Re: Case No. PU-11-680
Post Construction Inspection

Montana-Dakota Utilities Co. (Montana-Dakota), a Division of MDU Resources Group, Inc., herewith submits the original and two (2) copies of its responses to the list of actions recommended in the post construction inspection report issued by Wenck Associates, Inc on December 10, 2014 (Wenck Report) and staff questions submitted on September 10, 2015.

Attachment D
PHOTO 8 - AREA OF CONCERN
Page 1 of 4

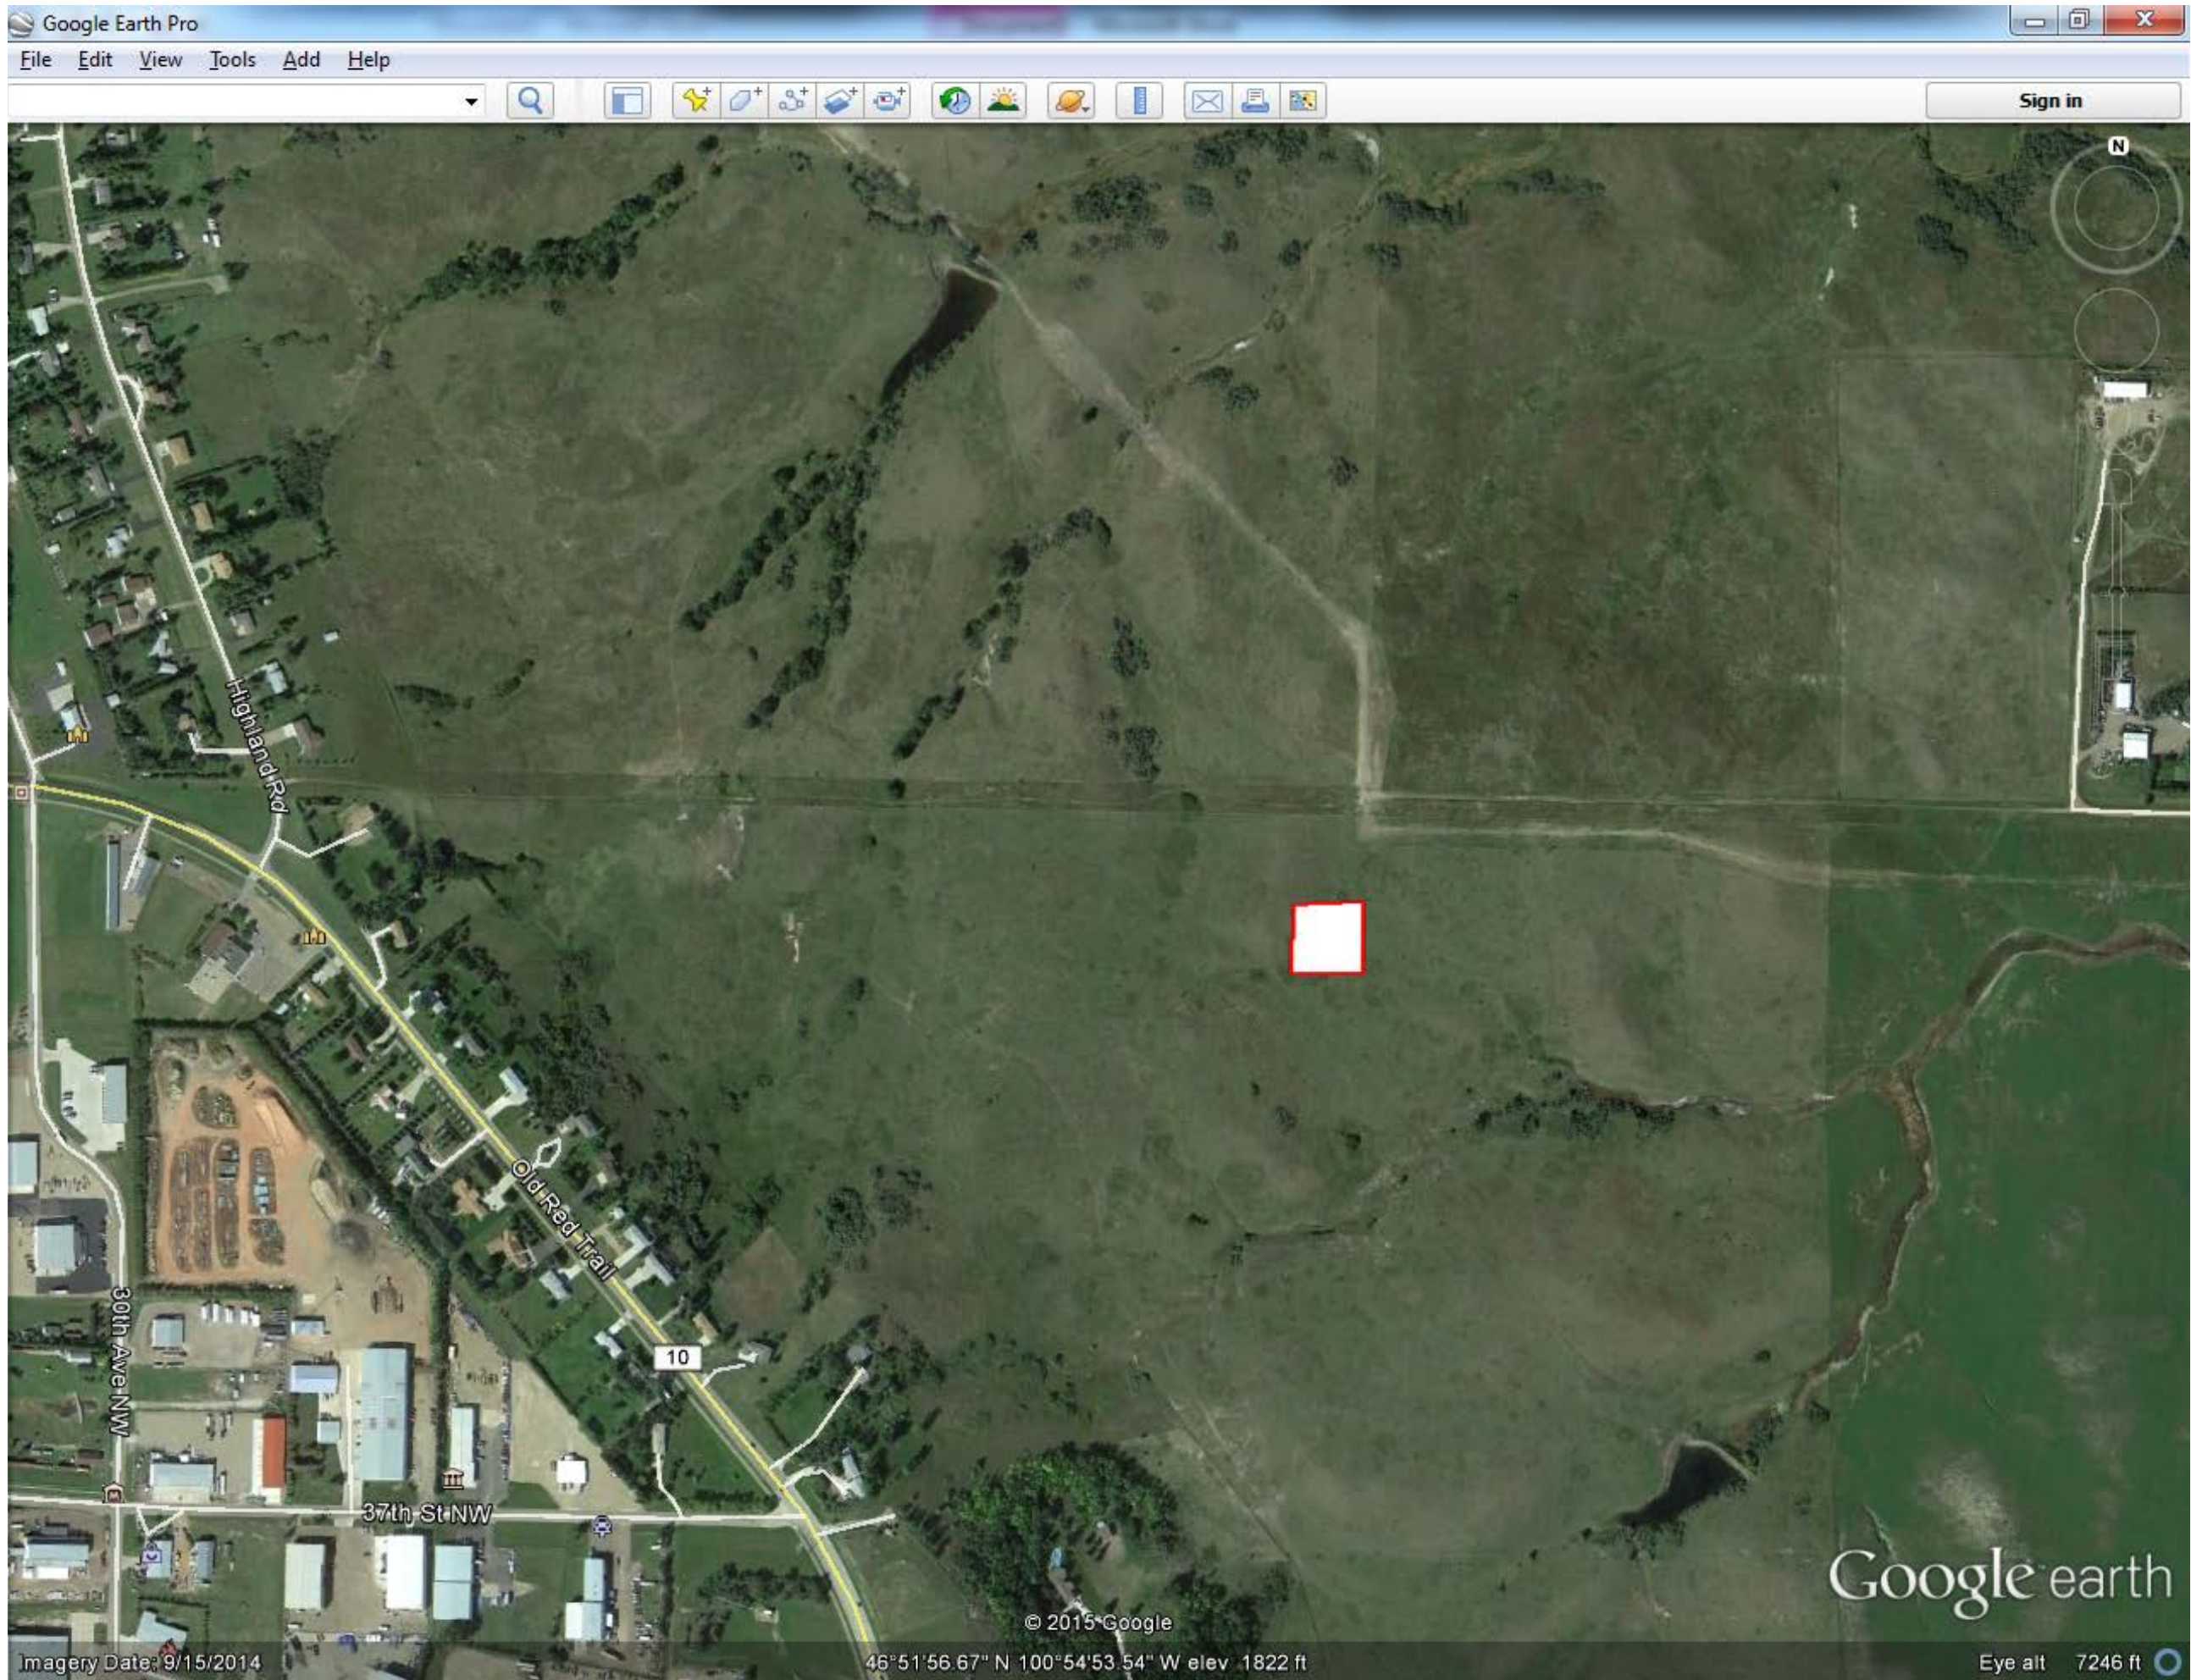
Area 2 – is an area of poor vegetation growth near Pipeline Marker N:388012.25 E:1847743.82. The Photo taken of this area from the Wenck Report is attached here as Attachment D Page 1 "PHOTO 8 – AREA OF CONCERN" and looking the other direction, Attachment D Page 2 "PHOTO 19 – AREA OF CONCERN". For Review Montana Dakota submits additional pictures taken in September 2015 entitled Attachment D Page 3 "Area of Photo 8 – Sept 2015" and Attachment D Page 4 "Area of Photo 19 – Sept 2015".

A review of these two areas of concern, shown in the pictures taken in September 2015, provide evidence that the vegetation has been restored to a condition that is equal to or better than the condition prior to the construction of the transmission facility and that the condition of the land will accommodate the previous use of the land.
